# SERVICE BULLETIN

SERVICE BULLETIN NO: 53-007

## FUSELAGE - FUSELAGE STRUCTURE INSPECTION FOR CORROSION IN FRAMES 3C AND REPLACEMENT OF WING ATTACHMENT BOLTS

FR 3C Assembly - Inspection and Replacement of Bolt Assembly  
Figure 1

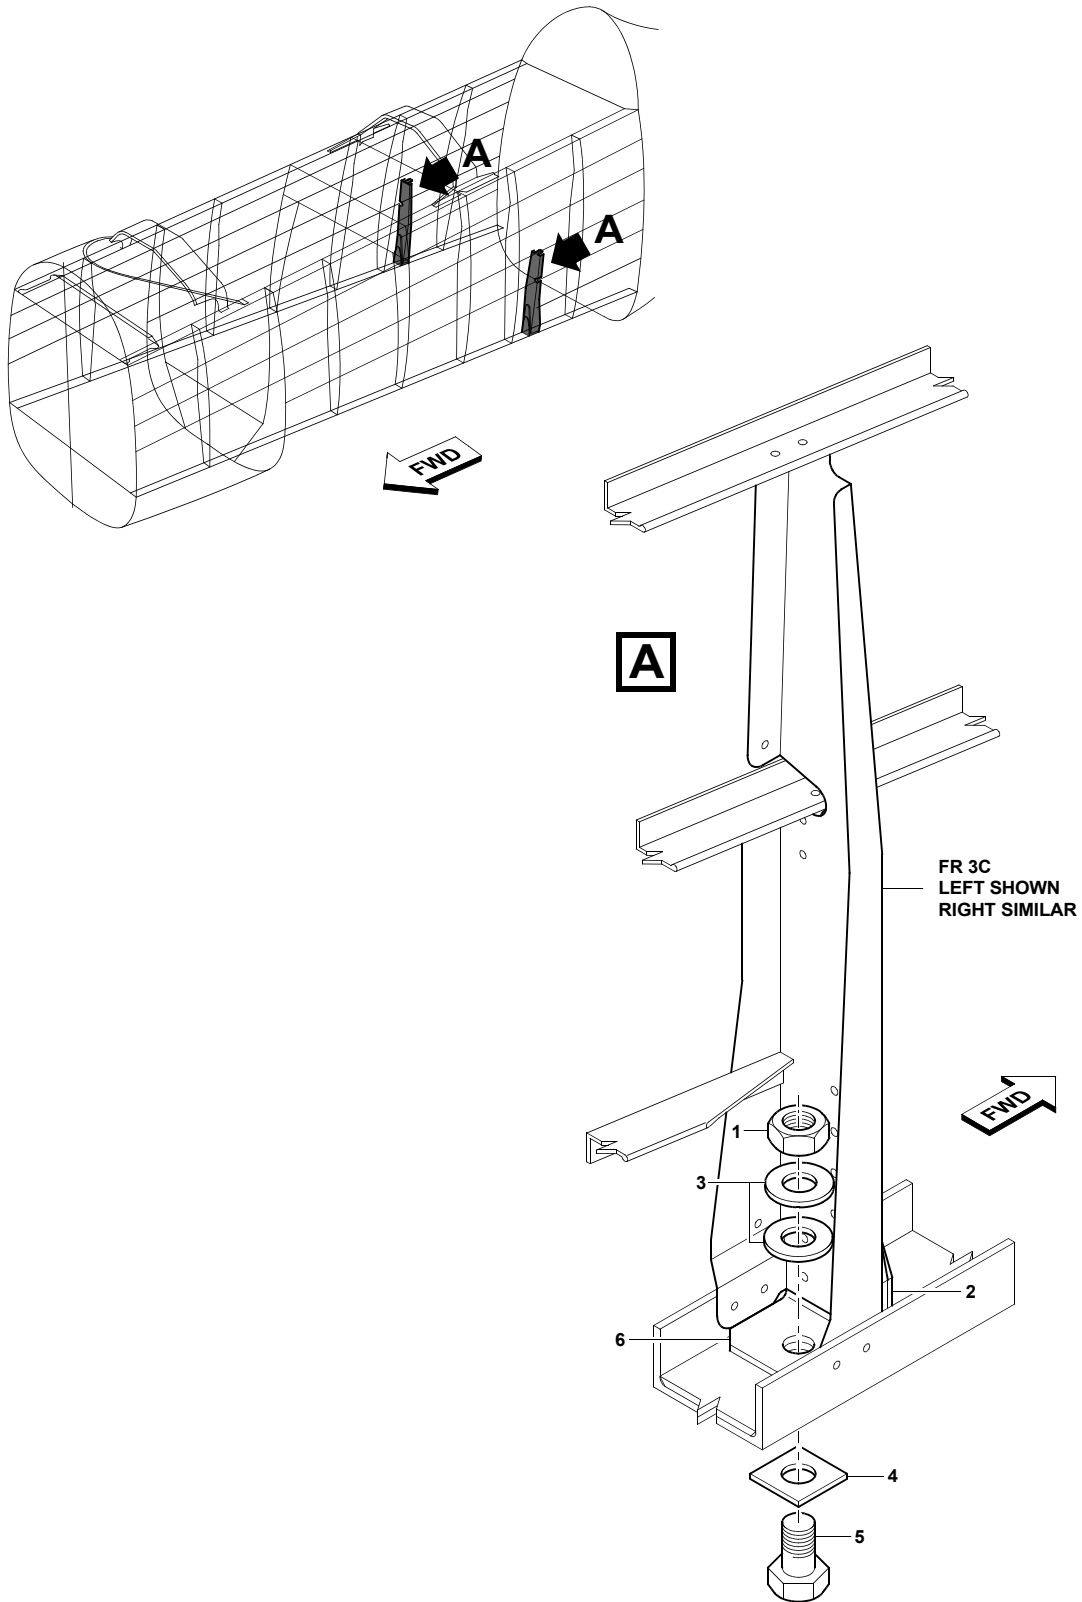
Corrosion has occurred in the pick-up brackets (brackets) (553.20.09.039) of Frame (FR) 3C in some aircraft. The brackets connect FRs 3C to the bottom, left and right longerons. They are also the locations for the wing bolts (bolts) (932.19.60.337).

Electrolytic action between the dissimilar metals of the bolts (932.19.60.337) and the brackets (553.20.09.039) has caused the corrosion.

- (a) Do inspections of the FR3C assemblies and adjacent structure for signs of corrosion
- (b) Replace the wing, rear attachment bolt assemblies with cadmium plated bolts. This will help to prevent corrosion in the applicable items
- (c) If necessary replace the FR3C assemblies and attaching parts.

- (1) Remove and discard the left nut (1), washers (3) & (4) and bolt (5).
- (2) Obey the manufacturers instructions and use the solvent (Material Item No. P01-008 or approved alternative) to clean the surfaces of hole for the bolt (1).
- (3) Use a source of bright light and a X 10 magnifier to do an inspection for signs of corrosion:
  - In the hole for the bolt (1)
  - On the bracket (6), shear plate (2), FR 3C and the adjacent structure.

Corrosion is not permitted in the bolt holes. Surface corrosion on the bracket, shear plate or FR 3C assembly is permitted if in limits (Ref. SRM, 53-20-00, Page Block 101). All other types of corrosion in the bracket, shear plate, FR 3C or the adjacent structure is not permitted. You must:

- Remove surface corrosion (Ref. Step 4)
  - Replace the bracket, shear plate and FR 3C assembly together if you find corrosion in one or more of them (Ref. SRM, 53-20-00, Page Block 201):
  - Apply to PILATUS for instructions if you find corrosion in the skin or structure adjacent to FR 3C.
- (4) If necessary remove the surface corrosion (Ref. SRM, 51-10-02, Page Block 1). You must replace the bracket, shear plate and FR 3C assembly (together) if it is not possible to remove the surface corrosion and stay in limits.
  - (5) Obey the manufacturers instructions and apply layers of the corrosion preventative (Material Item No. P04-012) on the faying surfaces of the new bolt (5), washers (3) & (4) and the bolt hole.
  - (6) Assemble the bolt (5) and washer (4), put the bolt in position and install the washers (3) and nut (1).

- (7) Torque the nut (1) to between 26 and 28 Nm (230 to 248 lbf in.).
- (8) Obey the manufacturers instructions and use the solvent (Material Item No. P01-008 or approved alternative) to remove unwanted corrosion preventative.
- (9) Apply layers of the corrosion preventative (Material Item No. P10-015) on the FR 3C assembly and adjacent skin and structure.
- (10) Do Steps (1) thru (9) again to:
  - Do an inspection for corrosion in the right bolt hole, bracket (5), shear plate (6), FR 3C and the adjacent structure.
  - Replace the right bolt assembly
